# HISTORIC AND DESIGN REVIEW COMMISSION

**HDRC CASE NO:** 2024-281  
**ADDRESS:** 141 ZERM RD  
**LEGAL DESCRIPTION:** NCB 7675 BLK LOT S 74.75 FT OF 4  
**ZONING:** R-6, H  
**CITY COUNCIL DIST.:** 3  
**DISTRICT:** Mission Historic District  
**APPLICANT:** Jenny Hernandez/HOWARD ROBERT D  
**OWNER:** Lucy Howard/HOWARD ROBERT D  
**TYPE OF WORK:** Amendment of a previously approved design regarding standing seam metal roof color  
**APPLICATION RECEIVED:** August 07, 2024  
**60-DAY REVIEW:** October 06, 2024  
**CASE MANAGER:** Edward Hall

## REQUEST:

# ROOF PLAN

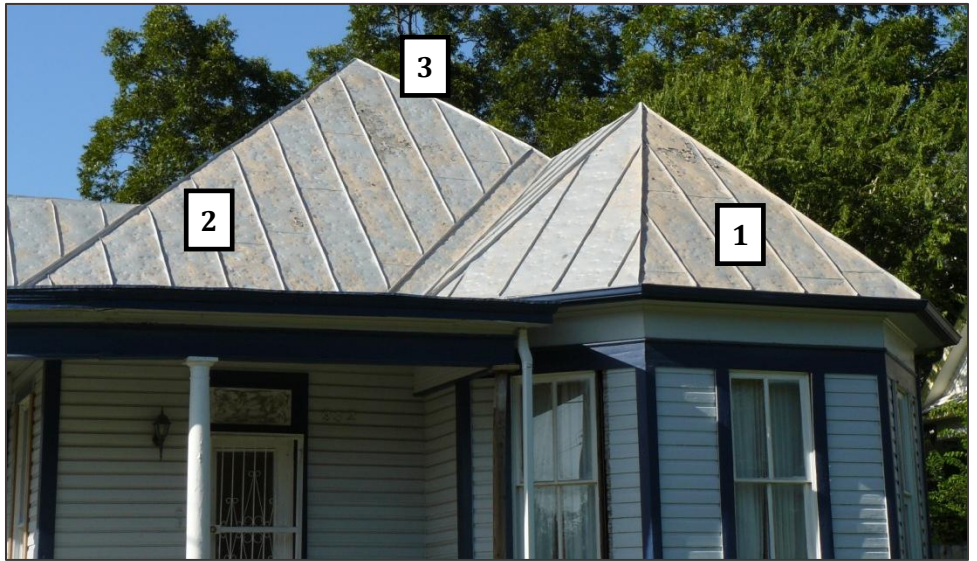
- a. The applicant is requesting a Certificate of Appropriateness for approval to install a black, standing seam metal roof at 141 Zerm, new construction located within the Mission Historic District.
- b. **PREVIOUS APPROVAL** – The new construction at 141 Zerm Road was approved by the Historic and Design Review Commission on June 7, 2023. A stipulation of that approval was the adopted standing seam metal roof standards, which specify panel width (18 to 21 inches), seam height (1 to 2 inches), ridge details (either a crimped ridge seam or a low profile ridge cap), and panel details (smooth with no corrugation or striations with a standard galvalume finish).
- c. **ROOF INSTALLATION** – The Guidelines for New Construction 3.A.iv. notes that new metal roofs should be installed in a similar fashion as historic metal roofs regarding their profile, panel details and color. Staff does not

find the installation of a black, metal roof to be appropriate within the Mission Historic District. Staff finds that the standard galvalume finish should be applied.

Staff does not recommend approval based on findings c. Staff recommends that a metal roof be installed that features a standard galvalume finish, consistent with the Guidelines.
